memorandum

SUBJECT: ZBA-2020-MAJ-06: A request by VitalSkin Physician Management, LLC, represented by

David Line, for a Major Variance to allow parking to encroach up to 14 feet into the required

15-foot front yard at 1111 West Kenyon Road in the B-3, General Business District.

Figure 1. Proposed parking configuration (excerpt).

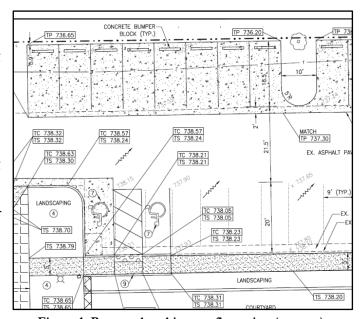
The applicant wants to construct an additional 14 parking spaces in front of the building: 2 more in the existing parking row, and a new row of 12 parking spaces along the northern property line (Figure 1.). There is approximately 61 feet between the south side of the parking lot and the northern property line (Exhibit D, Civil Sheet). The current row of 13 parking spaces (11 standard, 2 accessible) is 20 feet deep, leaving 41 feet of space between the parking spaces and the property line. The proposed configuration includes a 21.5-foot-wide aisle and an 18.5-foot-deep row of parking, leaving one foot of space between the edge of the parking area and the property line. The parking would avoid the mature trees along the northern property line.

dermatology clinic. They state that the available space between the access drive and the north property line does not allow them to construct additional parking without a variance, nor is there enough room to install the additional parking with a landscape buffer that would allow them to encroach up to 10 feet into the required 15-foot front yard without a variance.

As the applicant states, parking is permitted to encroach up to 10 feet into the required front yard in the B-3 district if a landscape buffer is installed.<sup>1</sup> Although the proposed parking configuration may be the most straightforward, staff does not find that it represents the minimum deviation from the Zoning Ordinance. There are alternative parking configurations that could be considered, where the option to install a landscape buffer and allow parking up to 10 feet into the required yard would eliminate the need for a variance, or at the very least would reduce the encroachment into the yard. This fact, coupled with the fact there are already 105 parking spaces on a site where only 91 parking spaces are required by the Zoning Ordinance, lead staff to recommend alternatives to the proposed configuration. Staff discussed several alternatives internally, and shared the three most feasible options with the applicant:
